**DRAWING SOLELY TO SHOW LOCATIONS OF  
PROPOSED WINDOW CHANGES AND  
EXTRACT AND PIPE ALTERATION**

| 886-P-012           | LANGLEY GREEN HOUSE |       |
| Elevational Key     |                     |       |

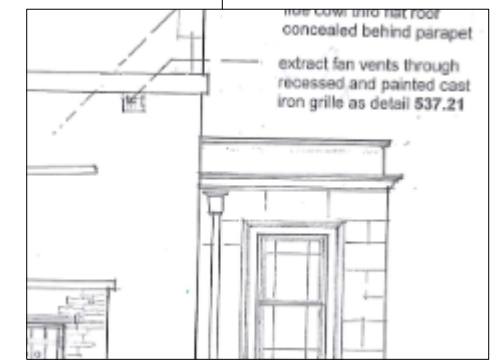
EXISTING SOIL PIPE ON CORNER EXTENDED  
TO FIT NEATLY BEHIND RWP WITHOUT  
DAMAGE TO PLINTH COURSES

WHERE UNREQUIRED SOIL PIPE NOT  
REQUIRED AND REMOVE . ANY PLINTH  
STONE TO BE REPAIRED WITH CAREFULLY  
PIECED IN MATCHING STONE

W01 PERMITTED ENSUITE WINDOW REPLACEMENT . REFER TO  
PROPOSED AMENDMENTS

EXISTING SOIL PIPE ON CORNER EXTENDED  
TO FIT CAREFULLY BEHIND RWP WITHOUT  
DAMAGE TO PLINTH COURSE S

W02 CURRENT WINDOW IN POOR CONDITION .  
REFER TO DAS FOR PHOTOS AND  
ACCOMPANYING TEXT

CONSENTED SCHEME SHOWED EXTRACT TO VENT ON NORTH  
ELEVATION ( SHOWN BLUE )  
REVISED SCHEEM PROPOSED EXTRACT ON EAST ELEVATION (   
SHOWN ORANGE AND WILL BE POSITIONED AS SHOWN SO  
NOT VISIBLE
